MECKLENBURG COUNTY
HEALTH DEPARTMENT

APPLICATION FOR A RESIDENTIAL SITE IMPROVEMENT PERMIT/ CONSTRUCTION AUTHORIZATION FOR AN ON-SITE WASTEWATER SYSTEM, NEW WELL INSTALLATION, OR REPAIR OF EXISTING WELL

SOIL/SITE EVALUATION
for ON-SITE WASTEWATER SYSTEM

IMPROVEMENT PERMIT DENIAL

Soil & Site Evaluation Map

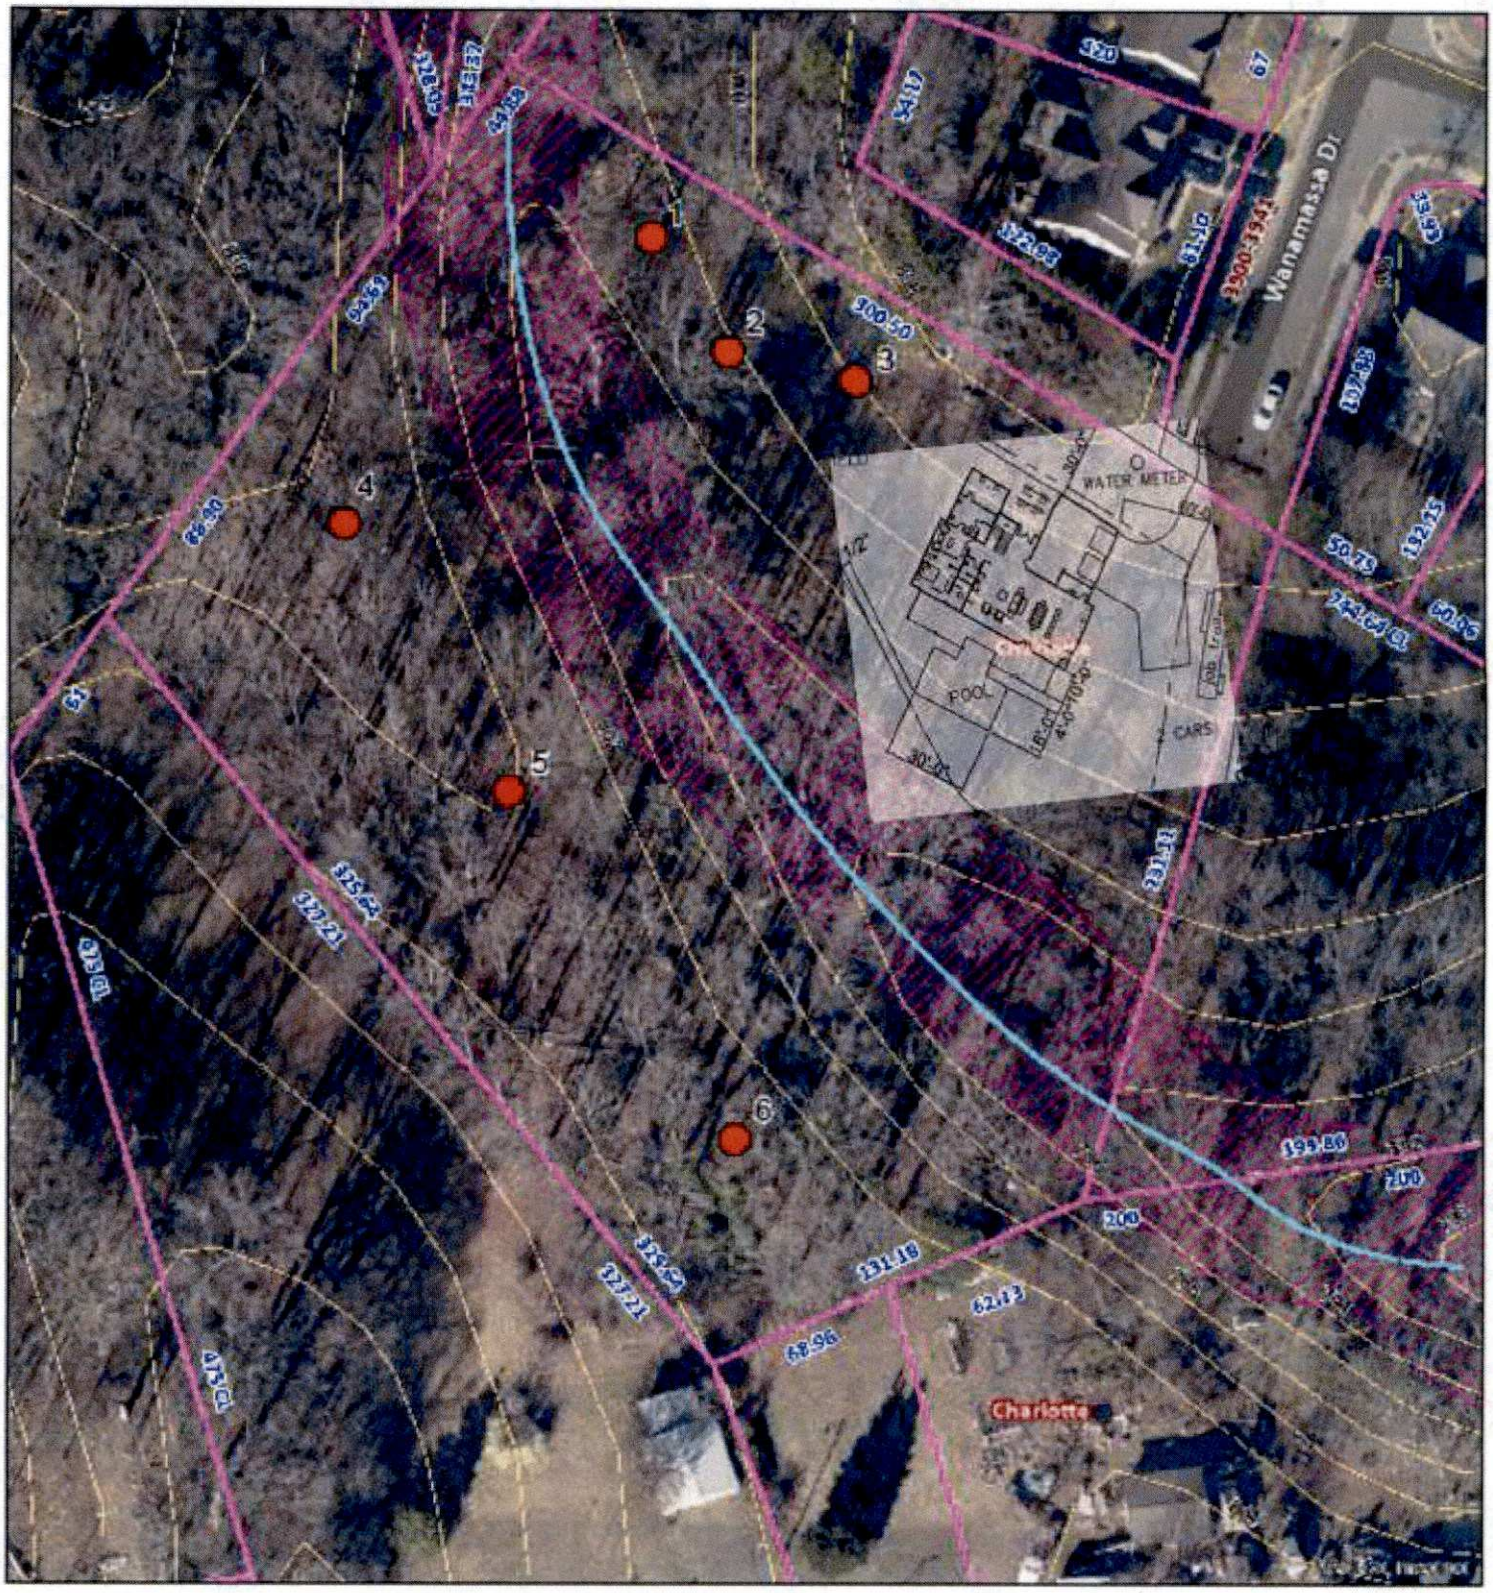
PROFILE #	.0502 Landscape Position/ Slope%	Horizon Depth (IN.)	SOIL MORPHOLOGY .0503 Structure/ Texture	.0503 Consistence/ Mineralogy	PROFILE FACTORS Matrix Soil Color	.0504 Soil Wetness/ Color	.0505 Soil Depth (IN.)	.0506 Sapro Class	.0507 Restr Horiz	General Comments / Other	0.0509 Profile Class & LTAR	0.0502 Slope Correction *(Low Side of trench)*
1	FS 5%	0 - 3	Wk, Sbk, CL	Fr, SS, SP	B	C-M: Bl Mn concen. & YB deplet. @ 3"+ C-M: 7.5YR 7/2 deplet. @ 9"+	≥ 32"	N/A	N/A	---	US @ 9"	-2"
		3 - 32	Wk, Abk, C	Fr, S, P, SE	YB							
		32	Boring terminated									
2	FS 5%	0 - 4	Disturbed - C	Fr, S, P	B	M: Bl Mn concen. & YB deplet. @ 4"+ C: G Chroma 2 deplet. & Bl Mn concen. @11"	≥ 24"	N/A	N/A	---	US @ 11"	-2"
		4 - 24	Wk, Abk, C	Fr, S, P, SE	YB							
		24	Boring terminated									
3	L 6%	0 - 29	Wk, Sbk, C	Fr, S, P, SE	R	C: Bl Mn concen. @ 6"+ F-C: G Chroma 2 deplet. & Bl concen. @ 15"-29" C: YB & Bl mottles 29"+	≥ 36"	N/A	N/A	Perched WT @ 15-29"	US @ 15"	-2"

29 - 36	Wk, Sbk, SC	Fr, SS, SP	R							
		36	Boring terminated									
4	R 4%	0 - 5	Wk, Sbk, CL	Fr, SS, SP	B	C: Bl Mn concen. @ 3"+ F-C: G Chroma 2 deplet. @ 13"+	≥ 39"	N/A	N/A	L-Sap. mixed throughout horizon @ 34"+	US @ 13"	-2"
		5 - 34	Mo, Abk, C	Fr, S, P, SE	YB-YR							
		34 - 39	Wk, Sbk, CL	Fr, SS, SP	YB							
		39	Boring terminated									
5	R 4%	0 - 4	Wk, Sbk, CL	Fr, SS, SP	B	C: YB deplet. & Bl concen. @ 4"+ F-C: G Chroma 2 deplet. @ 11"+	≥ 32"	N/A	N/A	F: Sap. Inclus. @ 30" +	US @ 11"	-2"
		4 - 29	Wk, Abk, C	Fr, SS-S, SP-P, SE	R							
		29 - 32	Wk, ABk, CL	Fr, SS, SP	YR							
		32	Boring terminated									
6	R 3%	0 - 3	Wk, Sbk, CL	Fr, SS, SP	B	C: YB deplet. & Bl concen. @ 7"+ F-C: G Chroma 2 deplet. & R concen. @ 18"+	≥ 34"	N/A	N/A	Pockets of gray EXP Clay @ 28" +	US @ 18"	-1"
		3 - 7	Wk, Sbk, L	Fr, SS, SP	B							
		7 - 34	Mo, Abk, C	Fr, S, P, SE	YB							
		34	Boring terminated

Based on the criteria set out in 15A NCAC 18E .0501 through .0602, the evaluation indicated that the site is **UNSUITABLE** for an on-site wastewater system. Therefore, we must deny your request for an Improvement Permit. A copy of the site evaluation is enclosed. The site is unsuitable based on the following:

- ☐ Unsuitable soil topography and/or landscape position (Rule .0502)
- ☒ Unsuitable soil characteristics (structure or clay mineralogy) (Rule .0503)
- ☒ Unsuitable soil wetness condition (Rule .0504)
- ☒ Unsuitable soil depth (Rule .0505)
- ☐ Unsuitable saprolite (Rule .0506)
- ☐ Presence of restrictive horizon (Rule .0507)
- ☐ Insufficient space for septic system and repair area (Rule .0508)
- ☐ Unsuitable for meeting required setbacks (Rule .0601 or .0602)
- ☐ Other (*Cite applicable rule*):_____

The site evaluation included consideration of possible site modifications, as well as use of all possible systems approved under 15A NCAC 18E. However, the Health Department has determined that none of the above options will overcome the severe conditions on this site. A possible option might be a system designed to dispose of sewage to another area of suitable soil such as off-site to additional property.

For the reasons set out above, the property is currently classified UNSUITABLE, and no Improvement Permit shall be issued for this site in accordance with Rule .0509(a) and (d).
